MLM-MARTIN
ARCHITECTS, INC.

Corrections #1 & Addendum # 1

Project: Orange County Three Points Maintenance (Young Pine)

Date: 2/28/2014 **File:** 97133-10-511-10

Z1186 OIL INTERCEPTOR

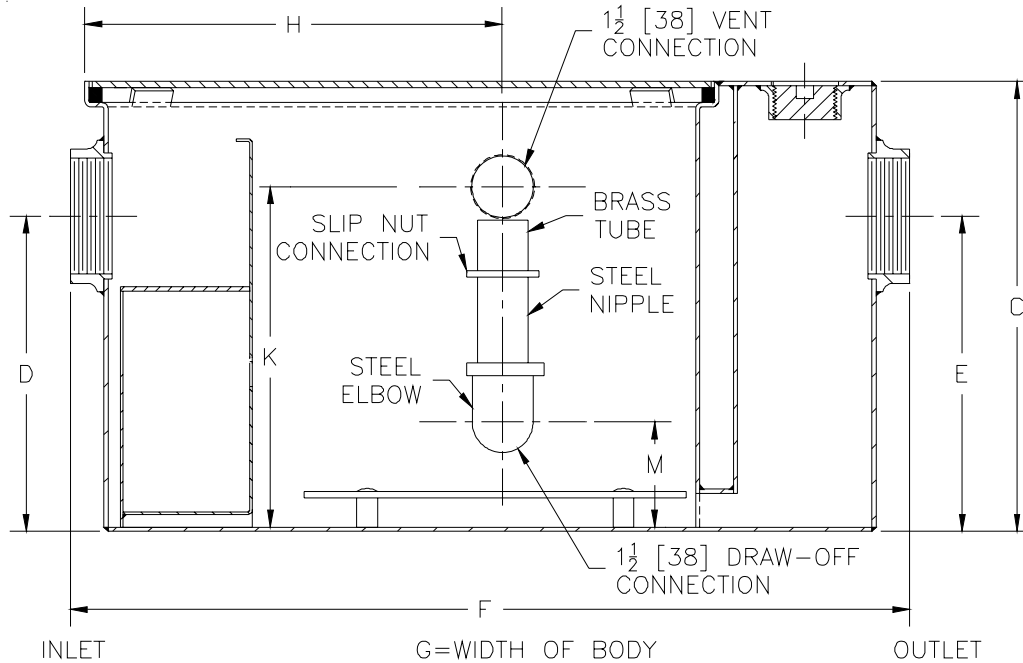
- Item #12: Sheet P3.3 Dated 02-28-2014
ADD: Oil-Water Separator and associated piping added to drawing. Note #15
added for description of separator. Updated border information.

- Item #1: Oil Water separator
